Technical Service Bulletin: TSB230043

Injector / Exhaust Gas Temperature Sensor (EGTS) Harness Bracket Conversion and Cable Tie Tension Optimisation to Improve Harness Restraint

Figure 1, Drilling Locations Indicated by Dashed Boxes.

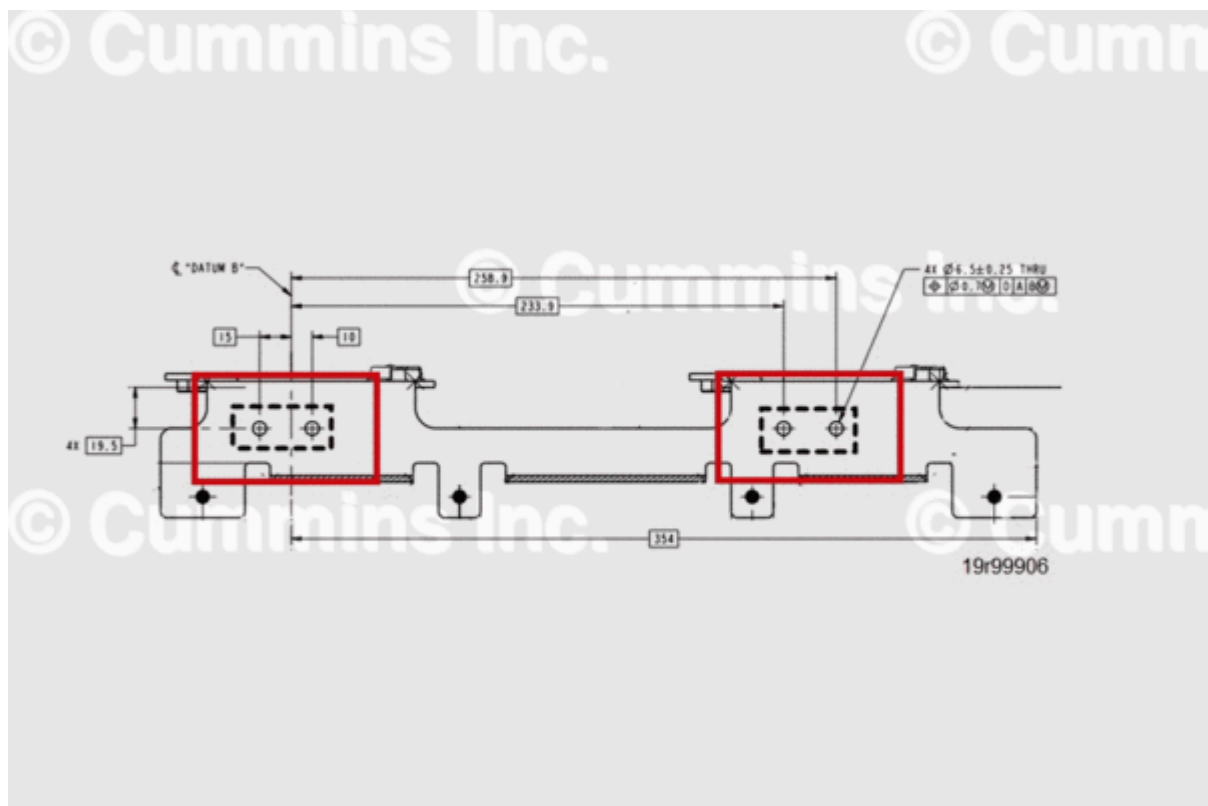
- The injector / EGTS harness bracket has been updated to include quantity 4 of 6.5 mm +/- 0.25 mm drillings to accept quantity 2 cable ties per bracket.
- The tension of cable ties has been increased.

1. Remove the injector / exhaust gas temperature sensor (EGTS) harness bracket from the engine.
2. Locate and centre punch the injector / exhaust gas temperature sensor (EGTS) harness bracket where holes are to be drilled, marked by the dashed boxes in the diagram in Figure 1.

3. Secure the work piece in a suitable vice.
4. Through drill each location using a 6.5 mm drill bit and suitable drill.
5. Deburr both sides of each drilling, using a suitable deburring tool.

6. Insert cable tie, Part Number 5286859, through the drillings in each location on the injector / exhaust gas temperature sensor (EGTS) harness bracket.
